ADDENDUM NO. 2 (AD-02)

RICHMOND REGIONAL JUVENILE DETENTION CENTER RENOVATION

SCO # 22-24596-02A

Date – 3/30/2023

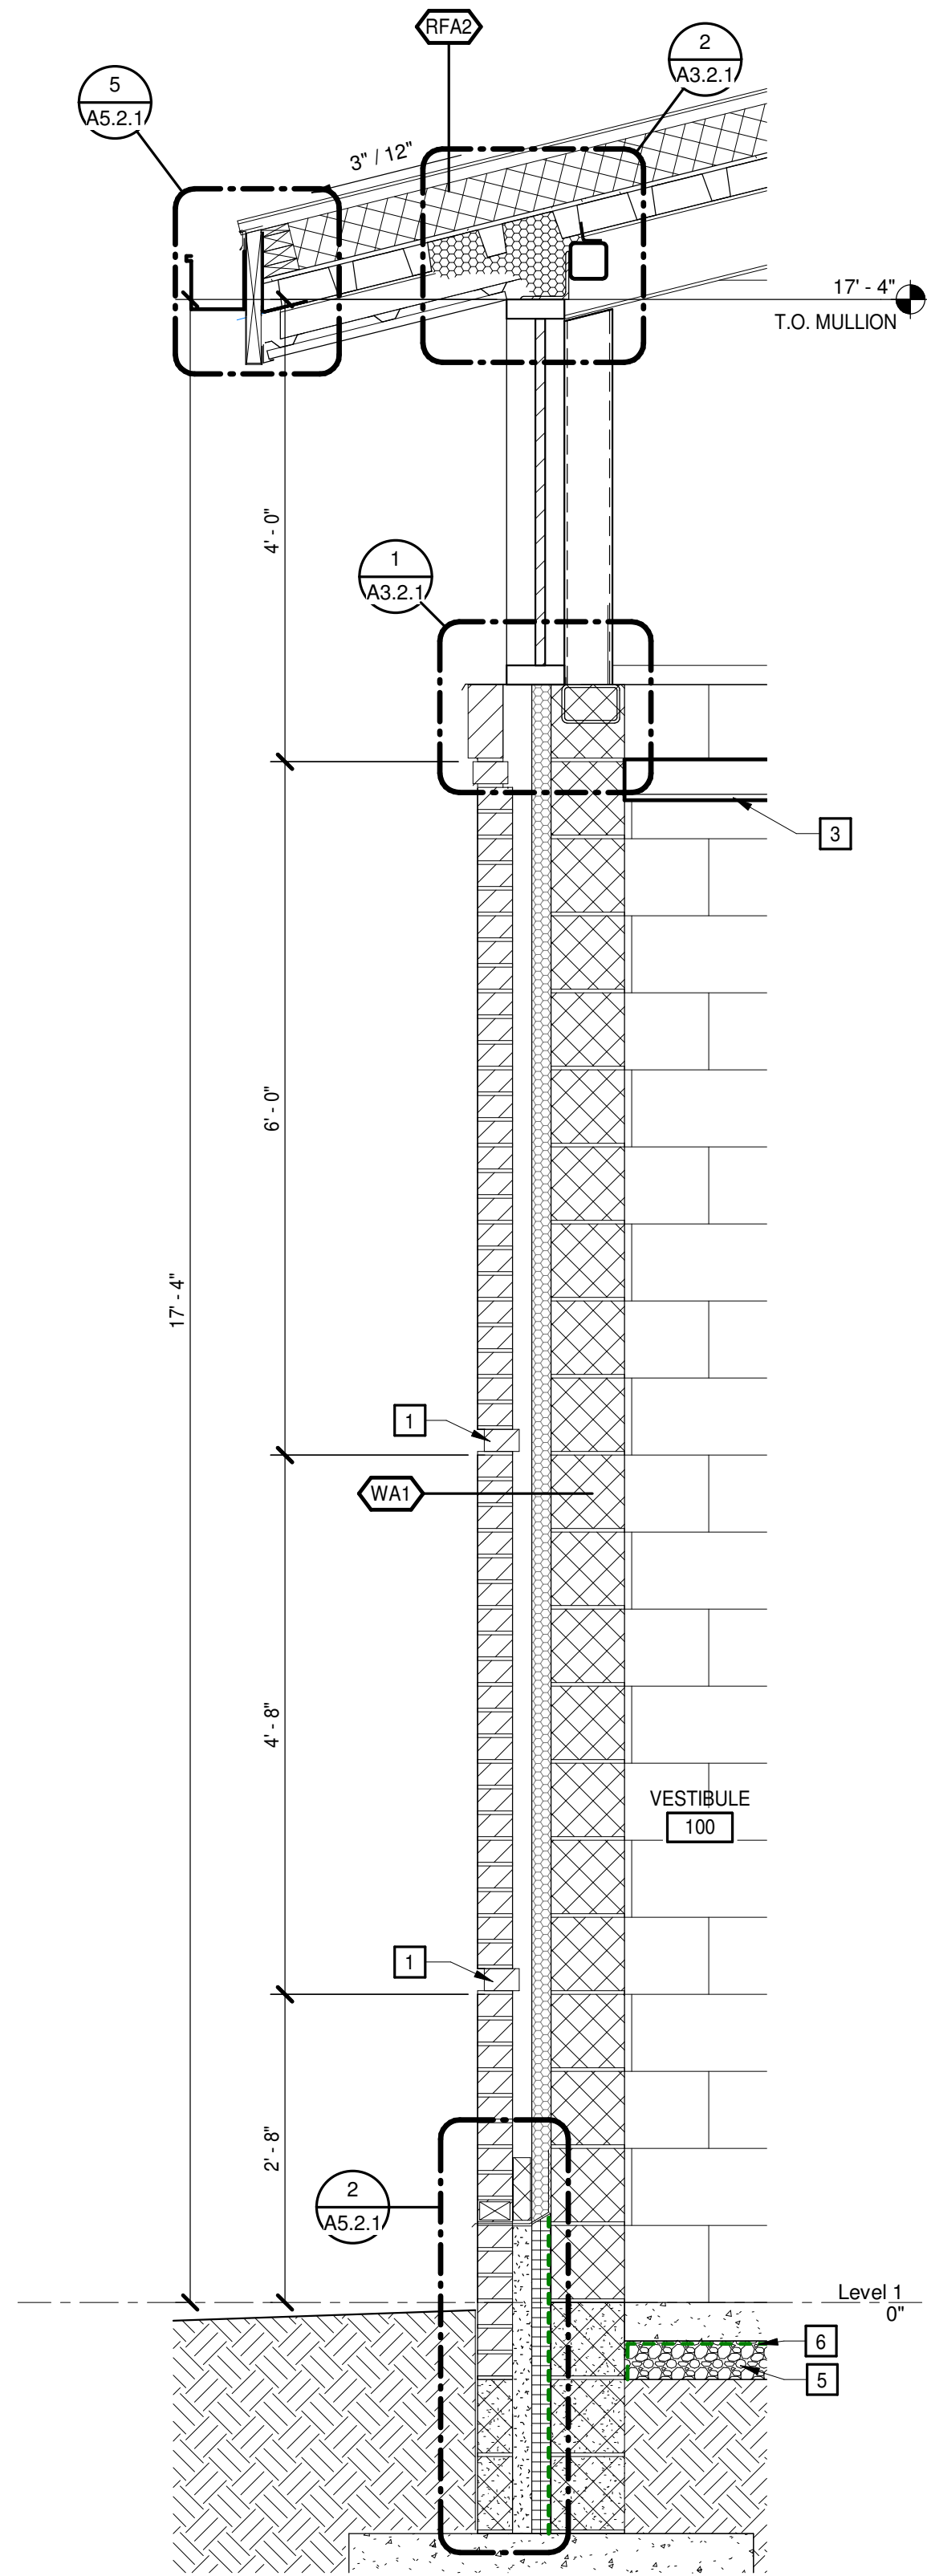
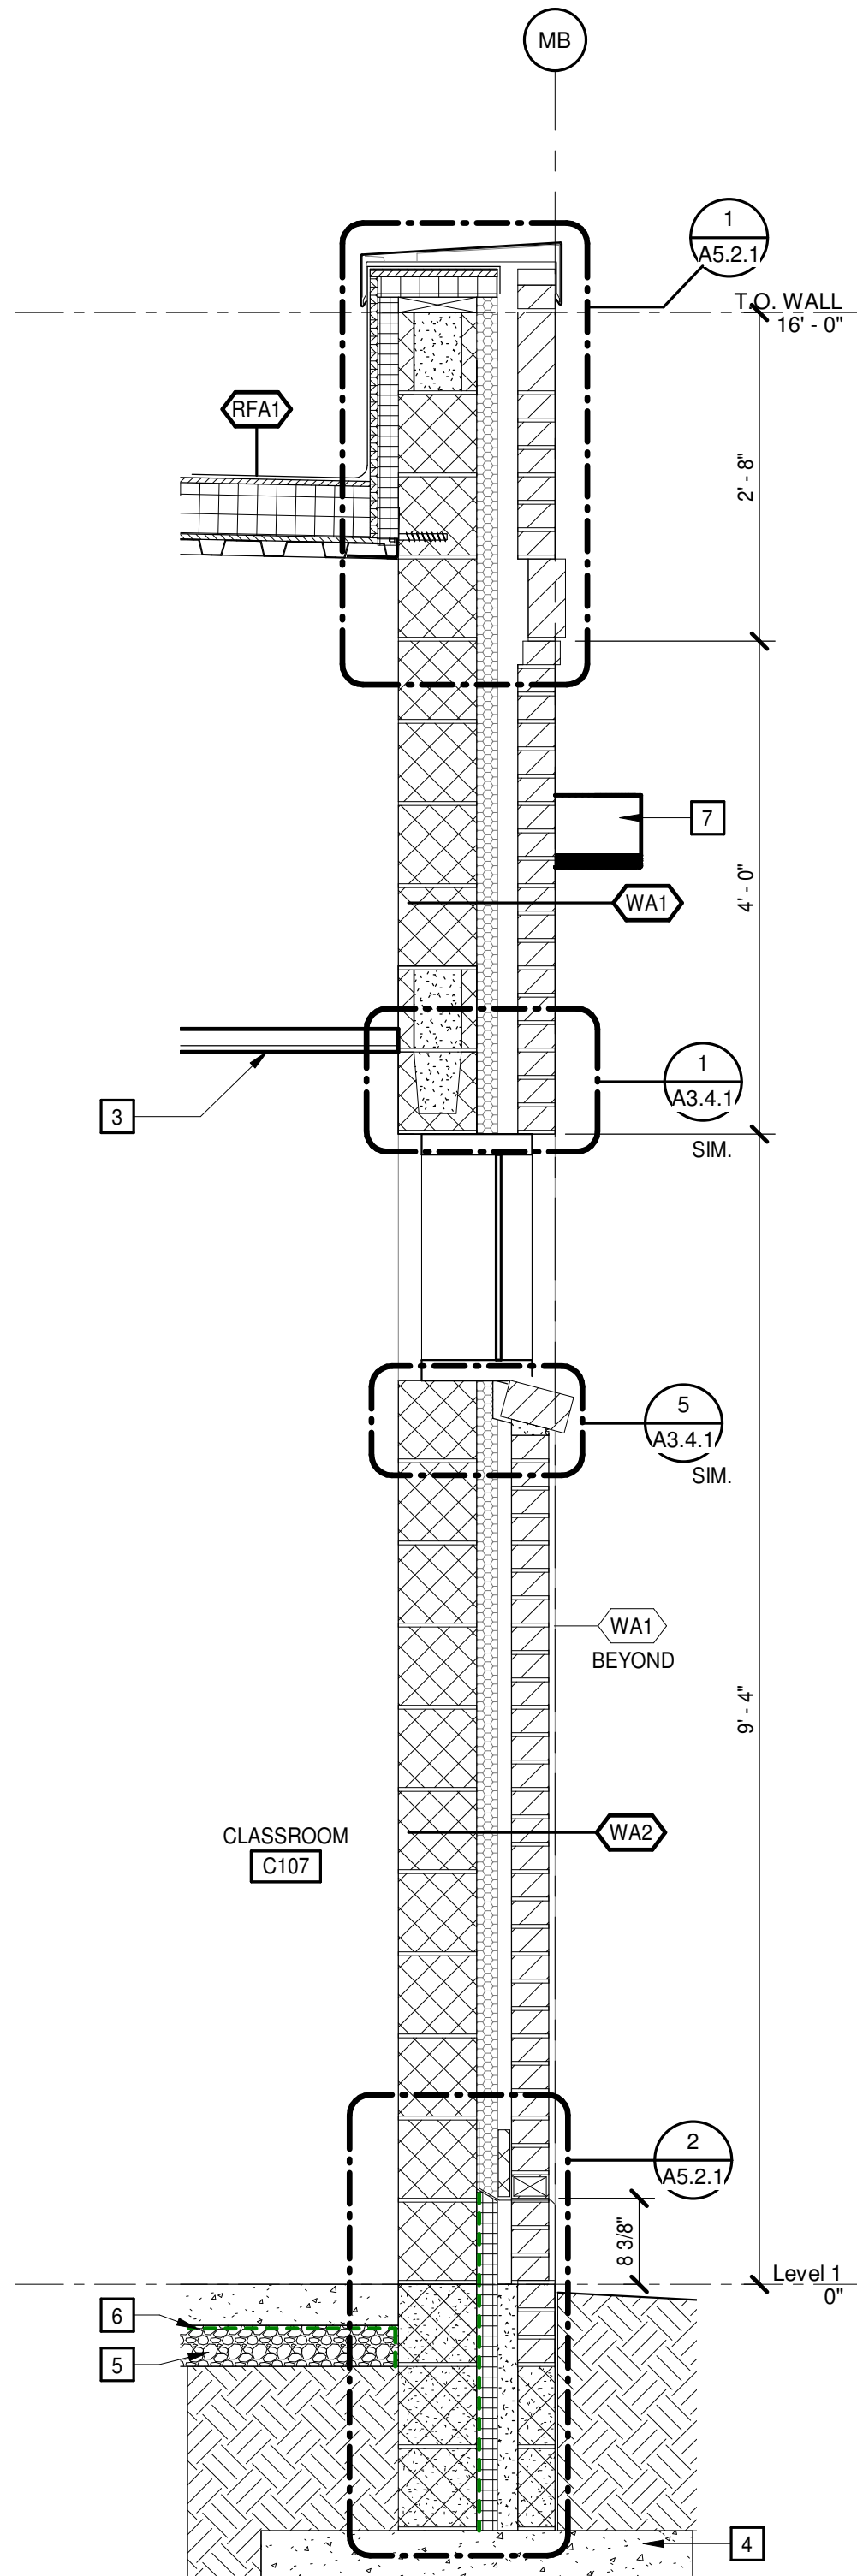
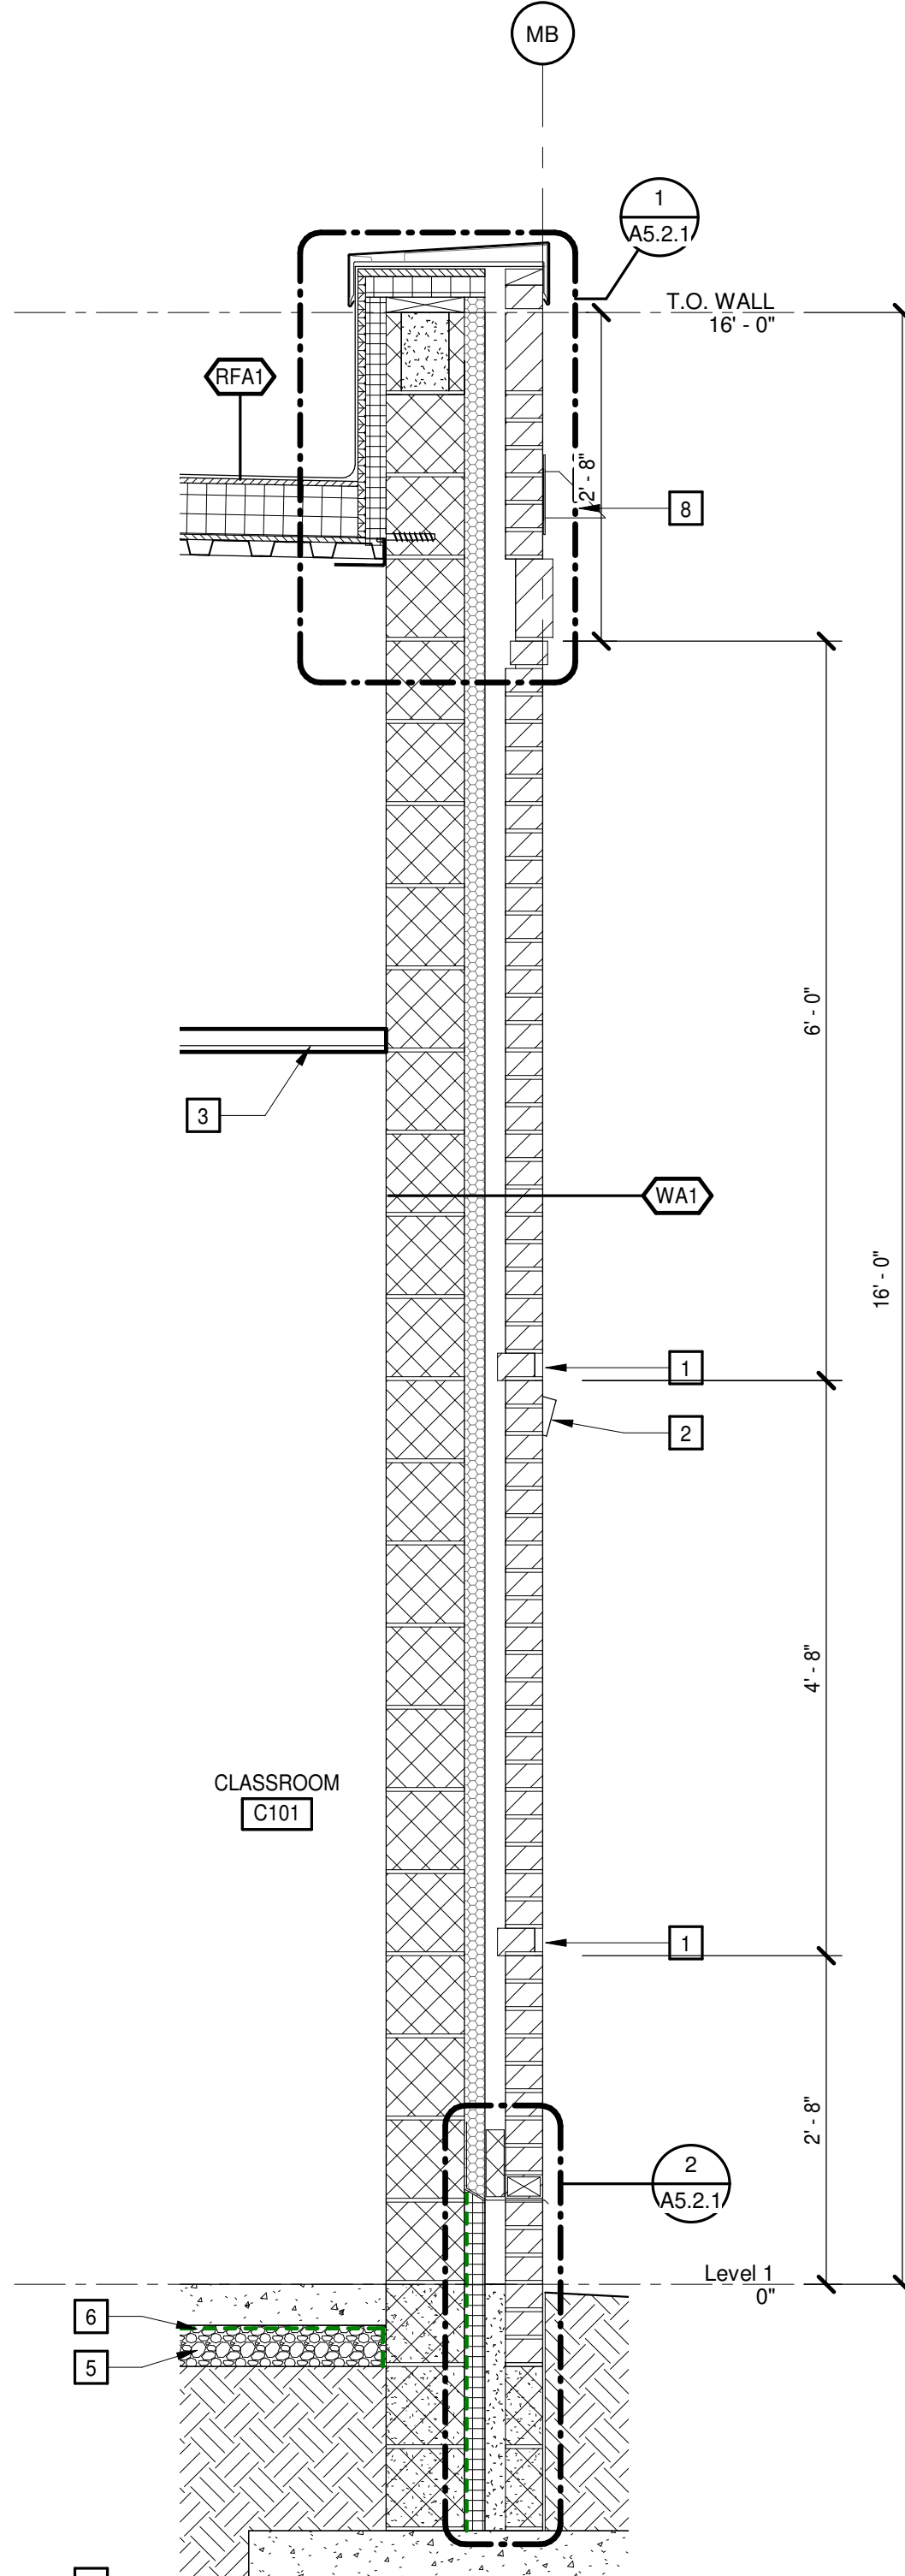
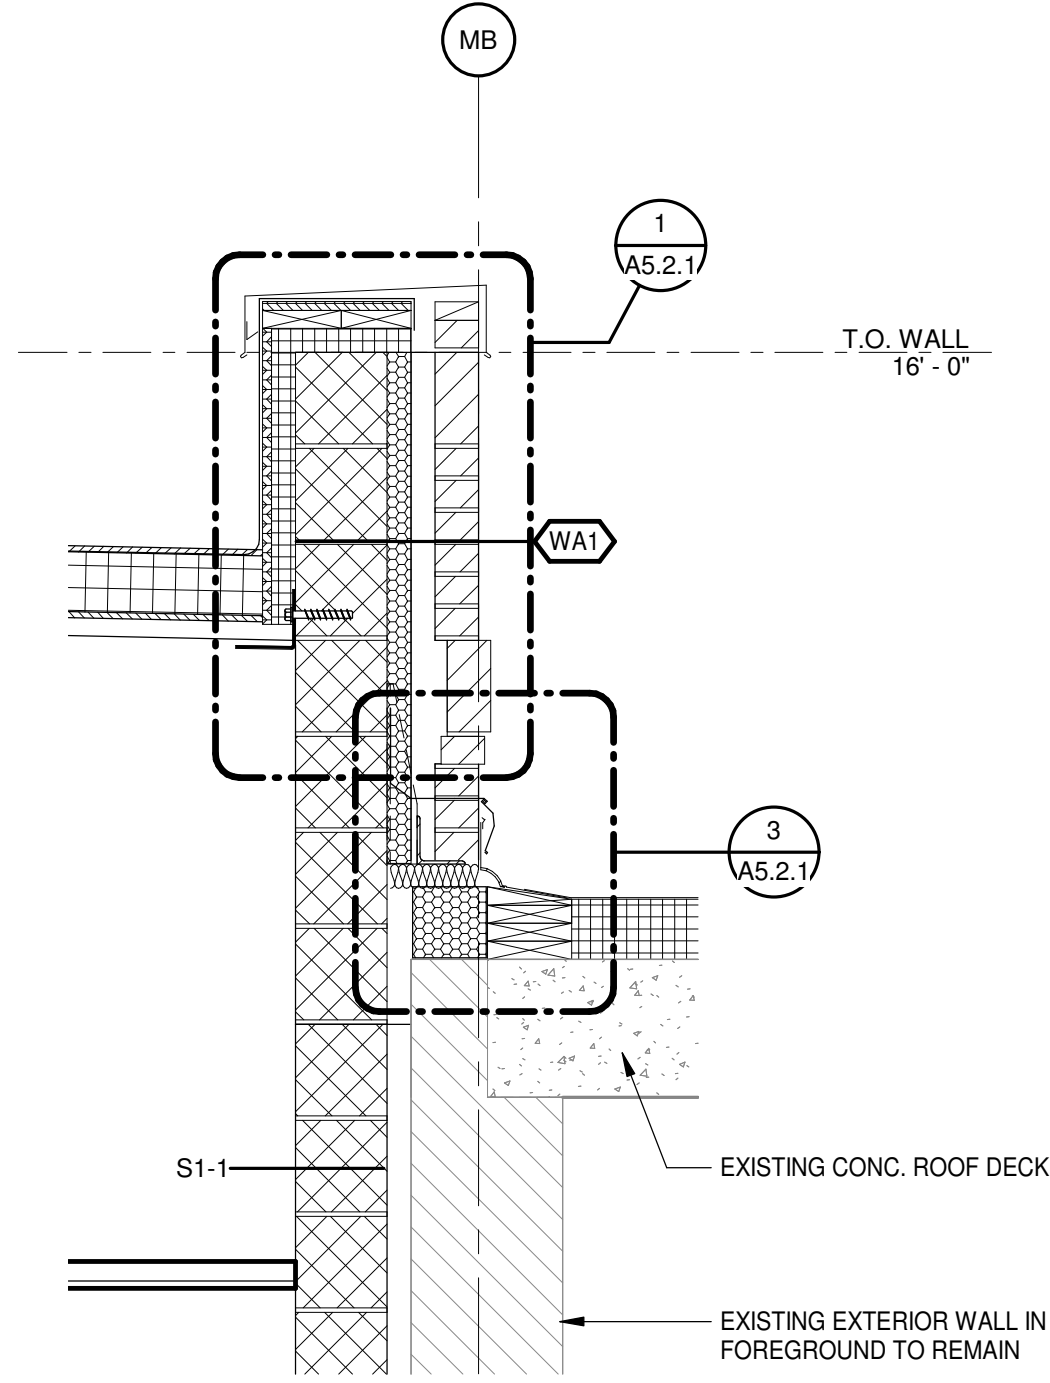
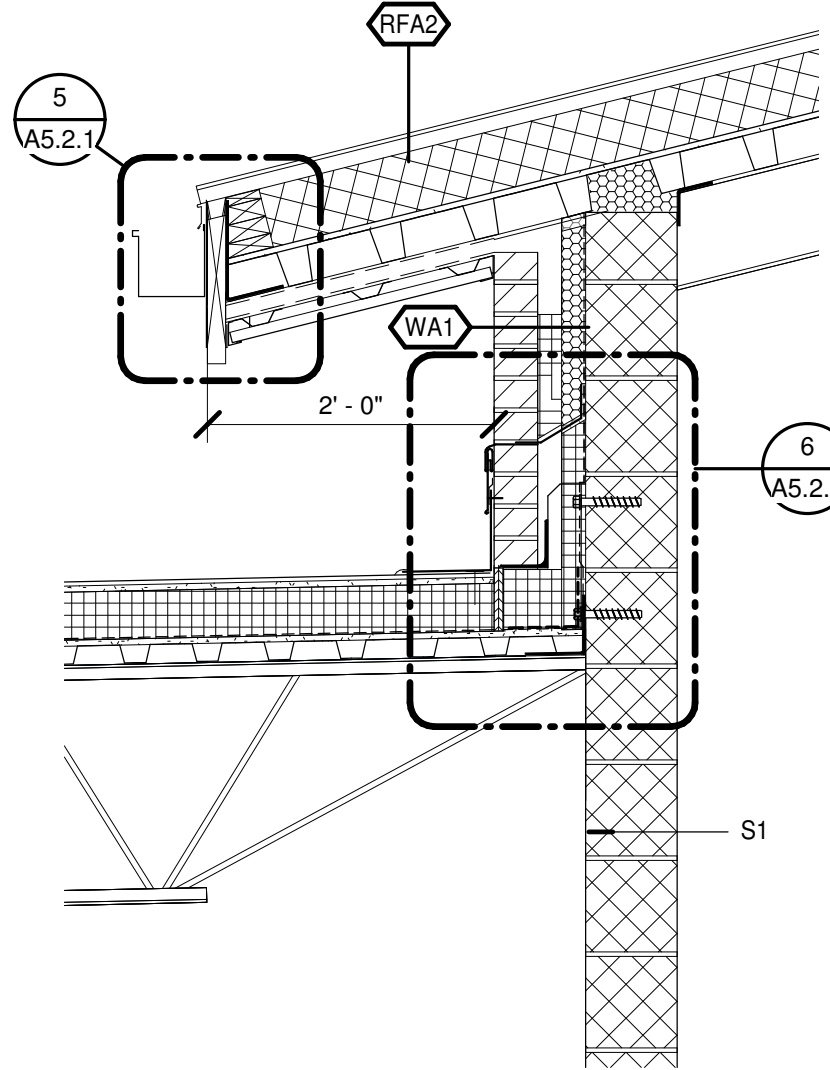
QUESTION: Question regarding the PEMB metal wall panels: Specifications 133419-11 call for a regular metal panel (non-insulated). Plans A0.2.0 (Wall Type WA3) call for an insulated metal wall panel. This is a conflict, which should we follow? According to wall type WA3, there is batten insulation sandwiched between two metal wall panels. Having an insulated metal wall panel on the outside will be likely be unnecessary and will greatly increase the cost of the PEMB.

ANSWER: Refer to revised Drawings attached.

MARK	FIRE RATING (REFER TO LS 1.1 FOR LEGEND)	REMARKS	INFORMATION
WA1 WA2			1'-3 1/4" @ WA1 1'-2 5/8" @ WA2 FACE BRICK AIR SPACE 2" SPRAYED POLYURETHANE FOAM AIR BARRIER 8" CMU
WA3			METAL LINER PANEL BATT INSULATION R-13 11" PEBB STEEL GIRT PEBB UNINSULATED METAL PANEL 3 5/8" METAL STUD @ 24" O.C. 5/8" IMPACT-RESISTANT GYP. BD.
